Docket No. 50-423
B11375

Millstone Nuclear Power Station, Unit No. 3
Revised Response to Question 480.9

Attached is Northeast Nuclear Energy Company's (NNECO) revised response to Question 480.9 in which NNECO was requested to provide the results of a nodalization sensitivity study for the pressurizer and steam generator subcompartments. In our original response to Question 480.9, which was submitted as part of Reference (1), NNECO committed to perform a nodalization sensitivity study for the pressurizer subcompartment analysis. As discussed in the attached response, NNECO has concluded that a nodalization sensitivity study is not necessary to justify the design of the pressurizer subcompartment. However, a reanalysis of the pressurizer subcompartment has been performed using a revised nodal model. The results of this analysis are provided in revised FSAR Section 6.2.1.2 which is attached.

FIGURE 6.2-24
PRESSURIZER SUBCOMPARTMENT
NODALIZATION DIAGRAM
MILLSTONE NUCLEAR POWER STATION
UNIT 3
FINAL SAFETY ANALYSIS REPORT

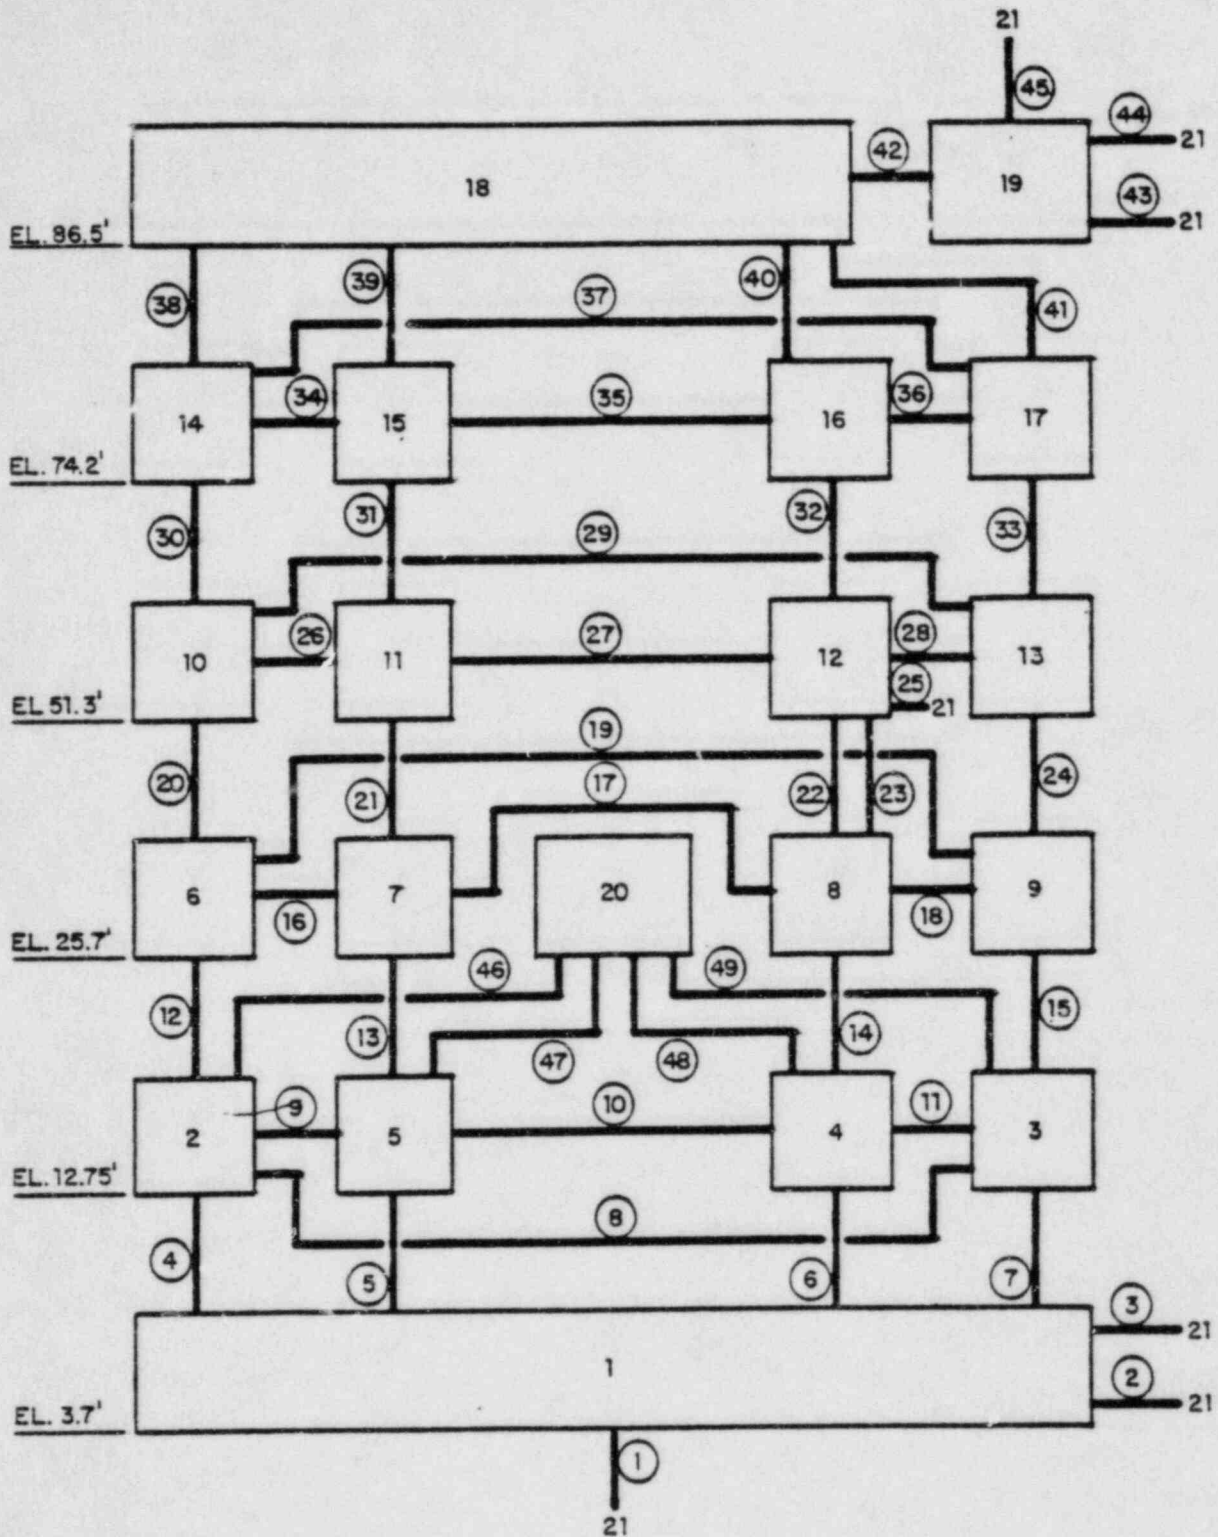
Question No. Q480.9 (Section 6.2.1)	1.12
Provide the results of a nodalization sensitivity study for the pressurizer and steam generator compartments.	1.13

Response:	1.14
A nodalization sensitivity study for the steam generator and pressurizer subcompartments is not necessary since the primary consideration in developing the nodal model was that there would be no pressure gradient due to geometry changes within a node. The model was constructed using the guidelines and recommendations of NUREG/CR-1199, Subcompartment Analysis Procedures, which discuss nodal complexity, or fineness, and its effect on analysis results.	1.15 1.16 1.17 1.18
The fineness of the nodalization is dictated by the location of major equipment and structural elements, or physical boundaries, which provide the locations for junctions between nodes. This approach provides adequate nodal fineness, as further refinement would add junctions at locations other than at significant flow influencing geometry. This is not good practice because it artificially adds a pressure drop where it would not be expected.	1.19 1.20 1.21 1.22 1.23 1.24

A nodalization sensitivity study was performed on the upper reactor cavity model and is discussed in FSAR Section 6.2.1.2. The results verify that adding junctions at locations where a pressure drop is not expected does not significantly affect the results. The steam generator and pressurizer subcompartment models are similar in fineness and were constructed in accordance with the same general guidelines as the limiting reactor cavity model. Therefore, further refinement of these models would not significantly change the results of the analyses.	1.25 1.27 1.29 1.30 1.32 1.33

The pressurizer cubicle is analyzed according to the nodalization diagram of Figure 6.2-24. The nodal complexity is consistent with recommendations of NUREG/CR-1199 (Gido 1979) and is discussed in detail in the response to NRC Question 480.9. 1.24
1.26
1.27
